SERVICE BULLETIN NO: 32-024

LANDING GEAR - MAIN GEAR INSPECTION OF THE MAIN-GEAR SUPPORT STRUT

PILATUS
PC-7
SERVICE BULLETIN

Type of Main-Gear Support Struts
Figure 1

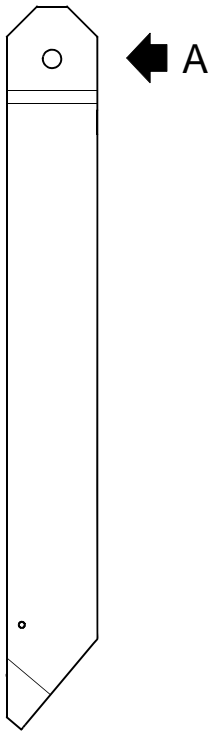
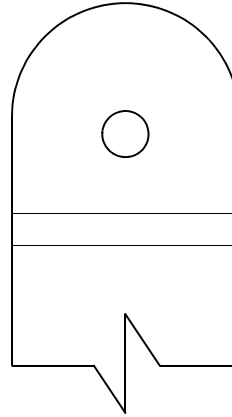
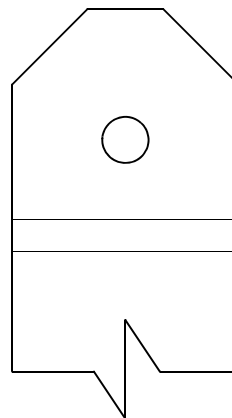
- (1) Do a visual examination of the left and right main-gear support struts installed on the aircraft:
 - If the main-gear support strut has rounded clevis lugs, it is made of material with an increased resistance to stress corrosion cracking. Continue the Service Bulletin from Step 3.E.
 - If the main-gear support strut has chamfered clevis lugs, it is made of material which has a lower resistance to stress corrosion cracking. Continue the Service Bulletin from Step 3.B.

- If the main-gear support struts has rounded clevis lugs, they are made of material with an increased resistance to stress corrosion cracking, and no further action is required.
- If the main-gear support struts has chamfered clevis lugs, they are made of material which has a lower resistance to stress corrosion cracking. Return the main-gear support struts (with chamfered clevis lugs) to Pilatus for replacement with a new part (P/N 532.10.09.128).

ROUNDED CLEVIS LUGS
NO NDI NECESSARY

CHAMFERED CLEVIS LUGS
NDI IS NECESSARY

Support Strut Preparation
Figure 2

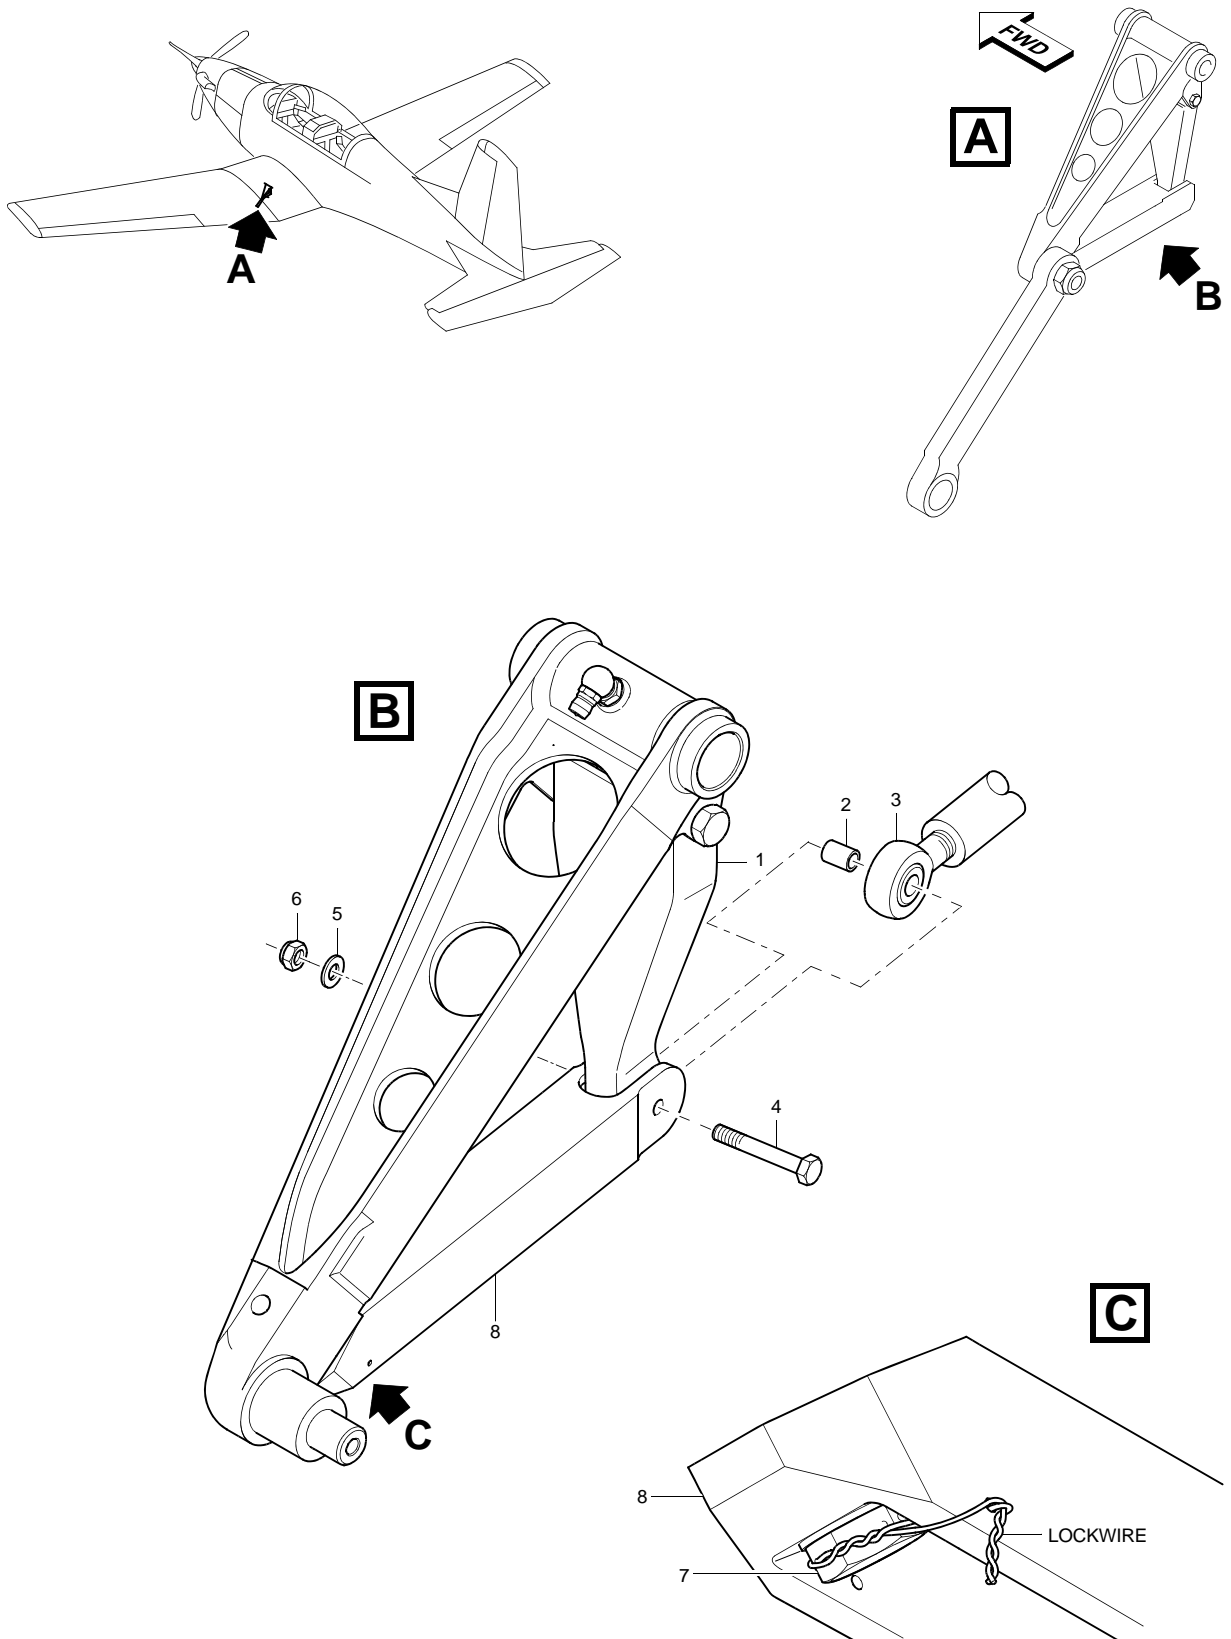
- (8) Remove the nut (6), the washer (5) the bolt (4) and the bush (2) and disconnect the actuator (3) from the left folding strut (1). Discard the nut (6).
- (9) Remove the lockwire between the bolt (7) and the main-gear support strut (8).
- (10) Use absorbent paper (Mat. No. P02-031) made moist with the solvent (Mat. No. P01-010) and clean the hole for the bolt (4), the hole for the lockwire and the adjacent area.

PILATUS AIRCRAFT LTD,
CUSTOMER LIAISON MANAGER,
CH 6371 STANS
SWITZERLAND
Fax: +41 41 619 61 70
 - (b) Do Service Bulletin 32-025 to replace the main-gear support strut.
- (9) If you do not find cracks (Ref. Fig. 2):
 - (a) Put the bush (2) in position in the actuator (3).
 - (b) Put the actuator (3) in the correct position between the lugs of the left and/or right folding strut lever (1).
 - (c) Install the bolt (4), the washer (5) and the new nut (6) (P/N 938.07.68.506).
 - (d) Safety the bolt (7) to the main-gear support strut (8) with the lockwire (Mat. No. P02-001).

Position of Possible Cracks
Figure 3

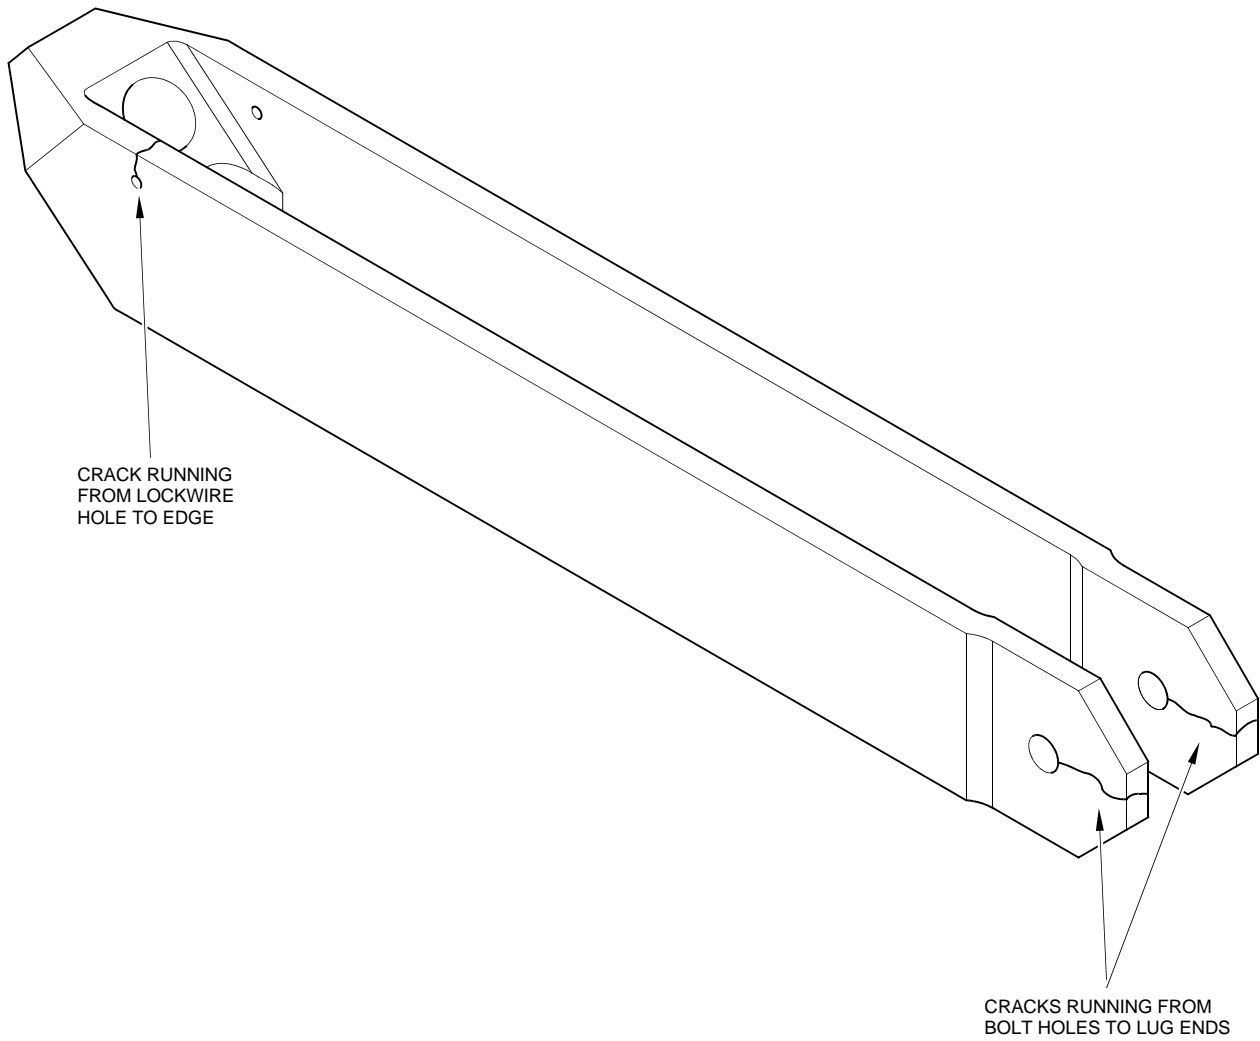
- (2) Examine both bolt holes of the left main-gear support strut for cracks with the rotating scanner probe.
- (3) Calibrate the eddy current 90° shielded probe instrument utilising the manufacturers handbook to represent a 75% of full screen height (FSH) response (null point represents 0% FSH) from the calibration standard.

- (4) Examine the area around the hole, for the bolt (4), on the aft surface with a 90° shielded probe.
- (5) Examine the area around the hole, for the bolt (4), on the forward surface with a 90° shielded probe.

- (6) Examine the area adjacent to the lockwire holes with the 90° shielded probe.
- (7) Do steps 3.C.(1) to 3.C.(6) for the right main-gear support strut.
